Revision: Issue 1
Date: 18th March 2015

NR Knitting Mills Ltd.

Structural Inspection Report

Observations

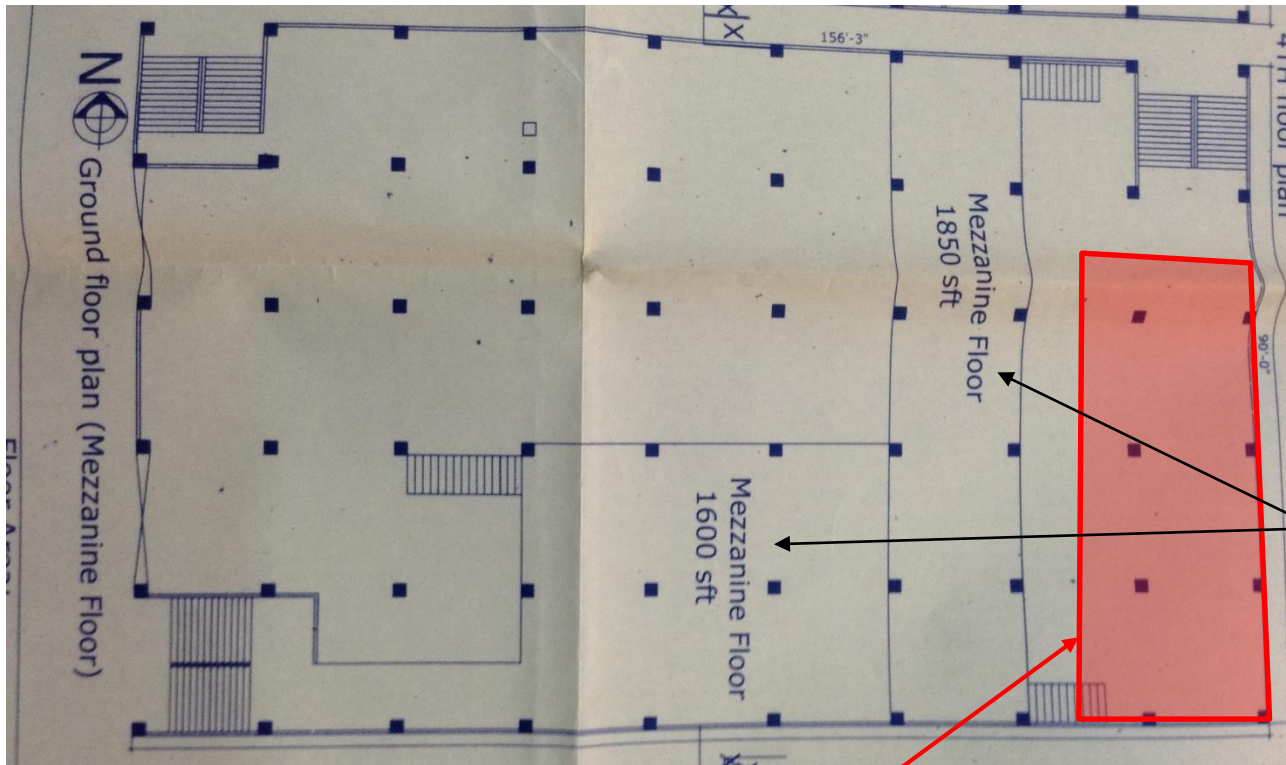
Highly-stressed columns

- Columns in this area are stressed to levels that require immediate review.
- Other columns appear to be stressed to levels in excess of normal design limits.

- Vacate and cordon off the area highlighted above at all levels **immediately**.
- Verify insitu concrete strength by 100mm dia. cores from min. 4 no. columns at ground floor level and min. 4 no. columns at 2nd floor level where aggregate changes to brick chips.
- A **Detail Engineering Assessment** of Factory to be commenced, see attached scope.

- Produce and actively manage a loading plan for all floor plates within the factory, giving consideration to floor capacity and column capacity.
- Detail Engineering Assessment to be completed.

Punching shear stresses in flat slabs

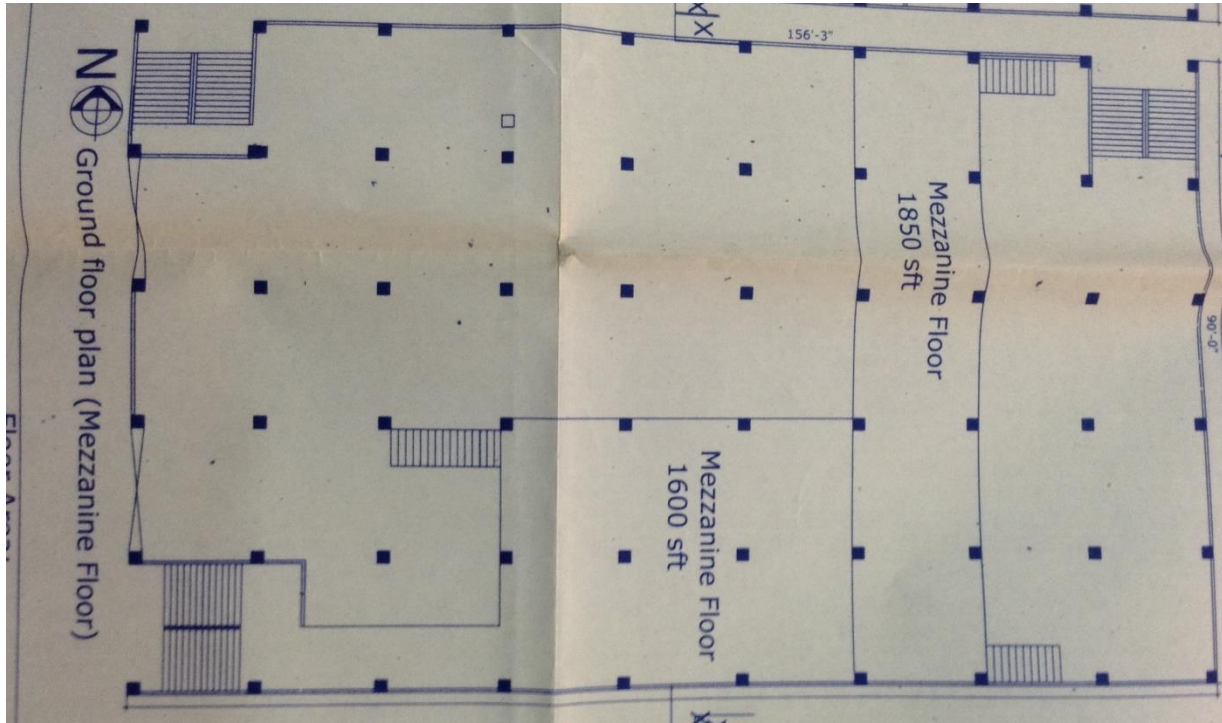
Flat slab at 2nd floor level and above –
punching shear stresses appear to be in
excess of normal design limits

- As part of Detail Engineering Assessment (see Item 1), verify insitu concrete strength by 100mm dia. cores from flat slabs at min. 4 no. floor levels. Cores to be taken near mid-span.
- Input results into loading plan (see Item 1).

Discrepancies between drawings and on-site observations

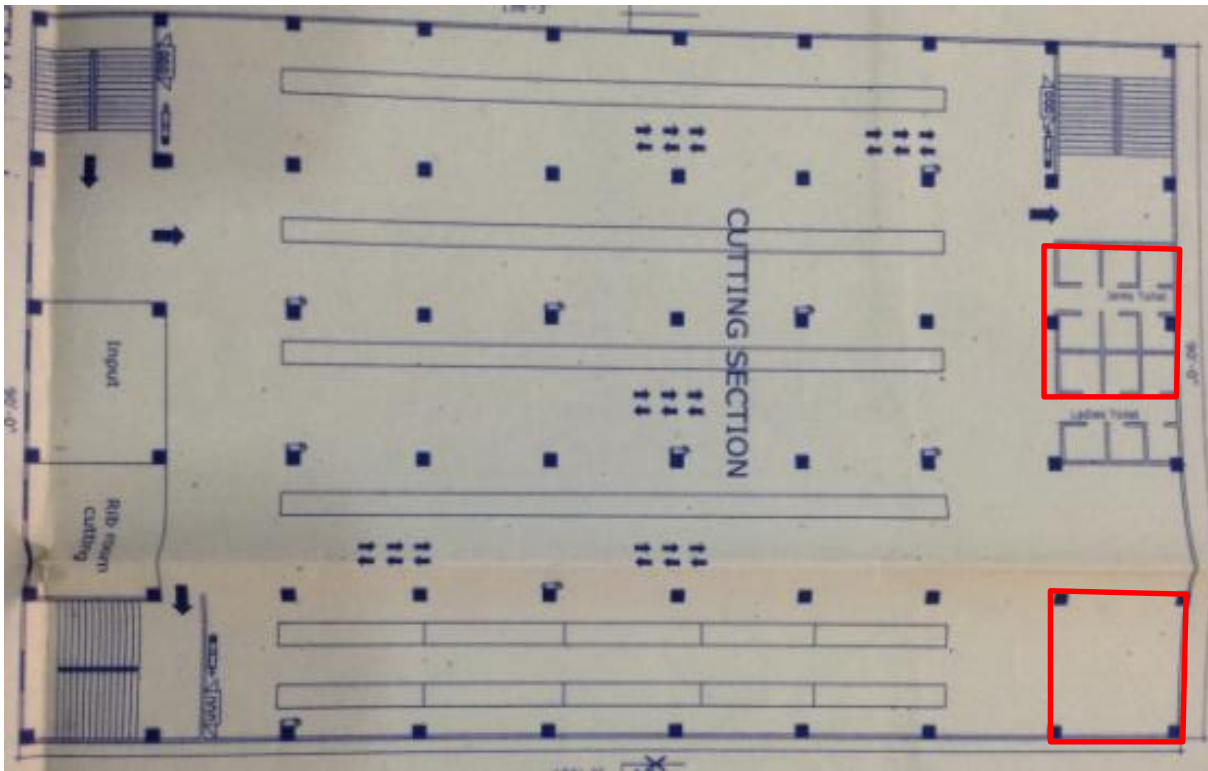
Toilet blocks as observed

Arrangements and location of the toilet blocks on the architectural drawing does not match with on-site observations

- As part of Detail Engineering Assessment (see Item 1), Factory Engineer to carry out survey of as-constructed building.

- As part of Detail Engineering Assessment (see Item 1), Factory Engineer to produce accurate as-constructed drawings for the building.

Item 1 and actions

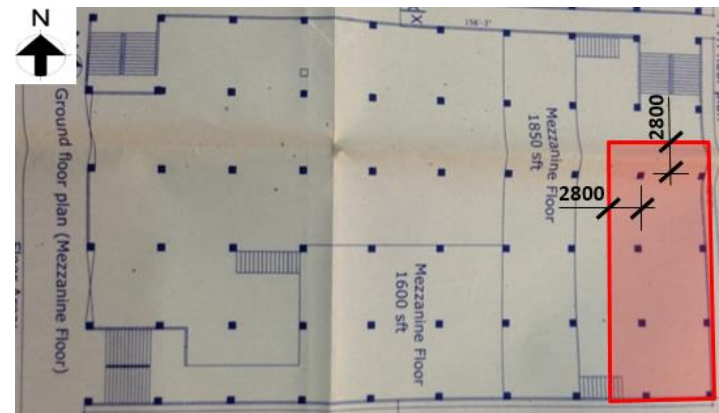
Highly-stressed columns

- Continue to implement loading plan.
